Access Compliance Report

Public Rights-of-Way

(Curb Ramps)

| Intersection ID: 17902 | Main Street: MONROE_RD | Cross Street: CONFERENCE_DR | Location: SE |

| ADA ID: 63AEEF218143 | Ramp Type: Perp | Initial Pass/Fail: Fail | Overall Compliance: No |

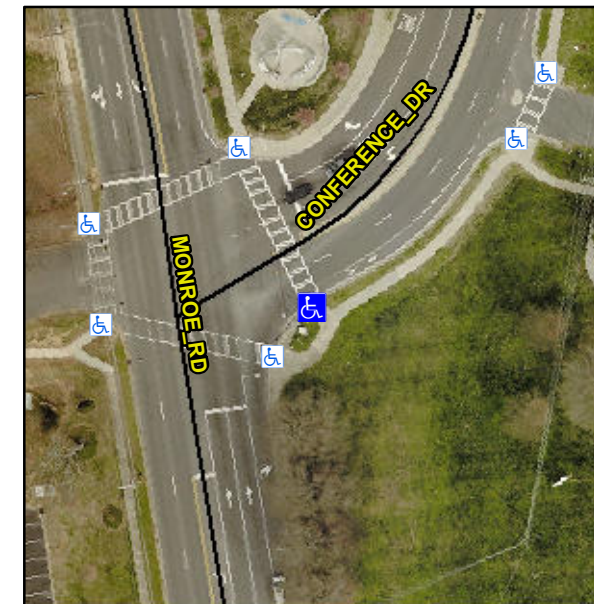
Not Found, R304.2.2, R304.5.3

| Compliance | Description | Data | Compliance | Description | Data |
|------------|-----------------------|-------|------------|-----------------------------|------|
| N/A | Ramp Length (in) | 52.0 | No | Ramp Slope (%) | 11.5 |
| Yes | Ramp Width (in) | 48.0 | No | Ramp XSlope (%) | 5.8 |

Remove & Replace Entire Ramp.
